Hood Cable Breaking or Binding

V-821-001

(February 2022)

All Volvo Trucks built between February 5, 2018, and February 28, 2022

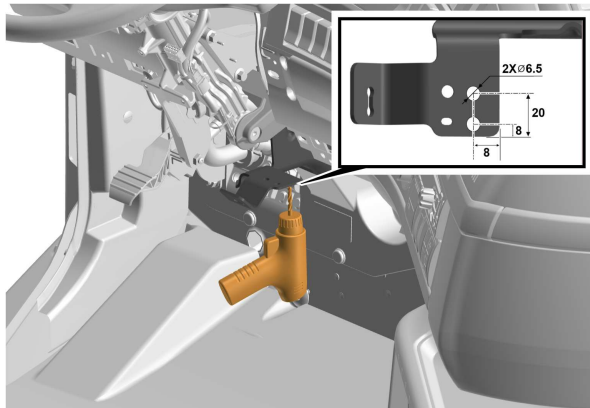
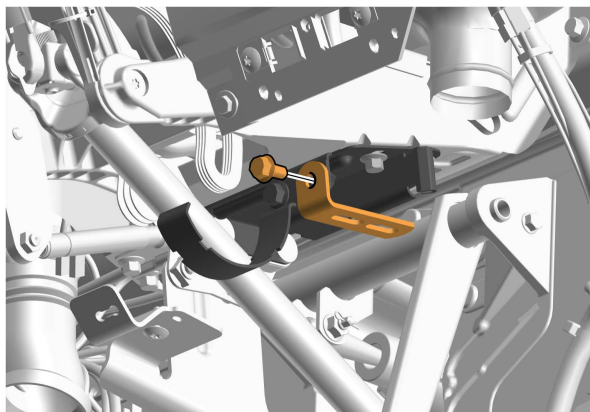
- 6 Follow procedure Function Group 8214, Information type Repair Hood Release Cable, Replacement in Impact to gain access to the cables.
- 7 Inspect cables for rubbing or binding around the steering shaft.
- 8 Replace Hood Release Cables as necessary following procedure Function Group 8214, Information type Repair Hood Release Cable, Replacement in Impact.
- 9 When installing new cable use new routing of cable shown below.
- 10 Drill two 6.5mm holes in the existing cable mounting bracket.

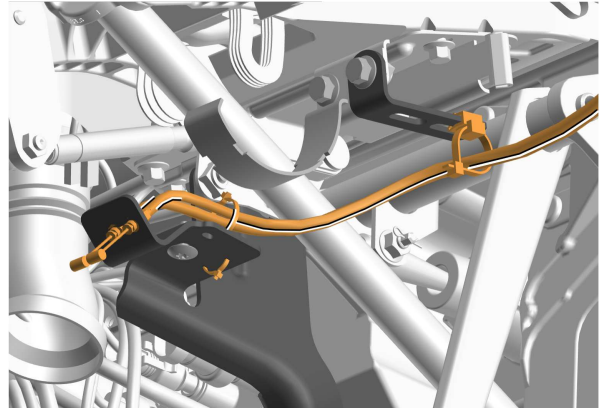
- 11 Add L bracket using existing screw and torque to spec.

36 Nm (26 lbf-ft)
